Well Name: HANCOCK A	Well Location: T28N / R9W / SEC 35 / SENE / 36.620789 / -107.751251	County or Parish/State: SAN JUAN / NM
Well Number: 5	Type of Well: CONVENTIONAL GAS WELL	Allottee or Tribe Name:
Lease Number: NMNM04209	Unit or CA Name:	Unit or CA Number:
US Well Number: 3004520820	Well Status: Gas Well Shut In	Operator: HILCORP ENERGY COMPANY

Notice of Intent

HILCORP ENERGY COMPANY
HANCOCK A 5
P&A NOI

CONDITIONS OF APPROVAL

HANCOCK A 5 - PROPOSED WELLBORE SCHEMATIC

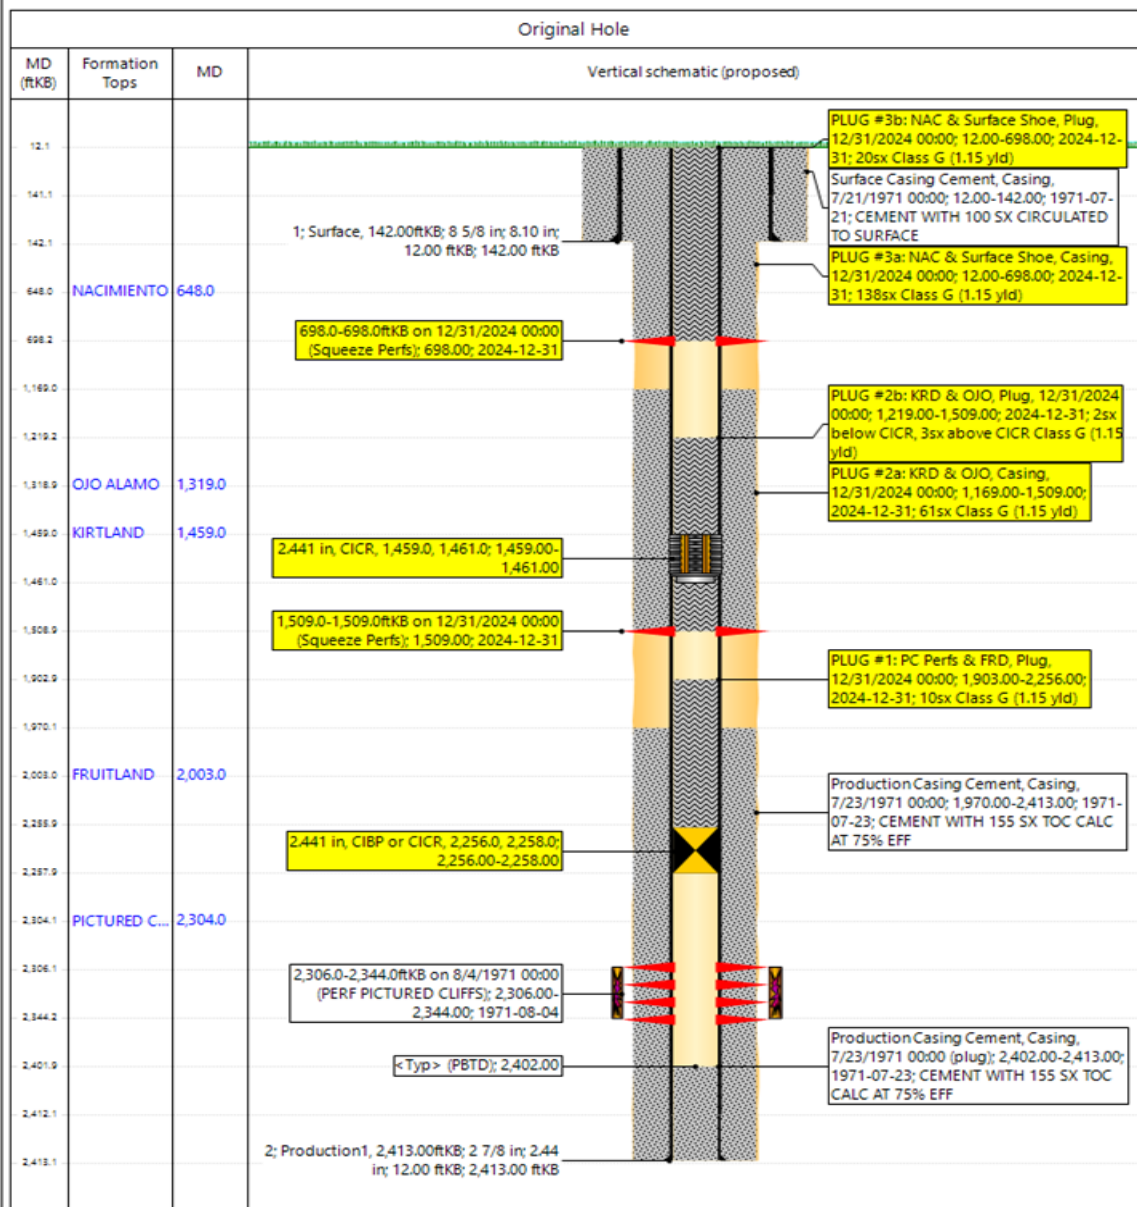
1. Plugging operations authorized are subject to the attached "General Requirements for Permanent Abandonment of Wells on Federal and Indian Lease."
2. The following modifications to your plugging program are to be made:
 - a. Move the Plug 1 TOC to 1730 ft to account for the BLM geologist's Fruitland top at 1830 ft.
 - b. Move the Plug 2 to 820 ft to account for the BLM geologist's Ojo Alamo top at 920 ft.
3. Farmington Office is to be notified at least 24 hours before the plugging operations commence at (505) 564-7750.

-Vertical wellbore, all formation depths are TVD from KB at the wellhead.
-Move the Plug 1 TOC to 1730' to account for the BLM geologist's
Fruitland top.
-Move the Plug 2 TOC to 820' to account for the BLM geologist's Ojo Alamo
top.
-The surface formation is the Nacimiento, therefore the bottom of Plug 3 may be
adjusted.

Created By	Condition	Condition Date
mkuehling	plug 1 should start 50 feet below pc top - bradenhead shows a steady flow - cannot combine plugs - follow BLM tops-- Notify NMOCD 24 hours prior to moving on - contact this office prior to running Kirtland plug - monitor string pressures daily - note findings in subsequent	3/14/2024
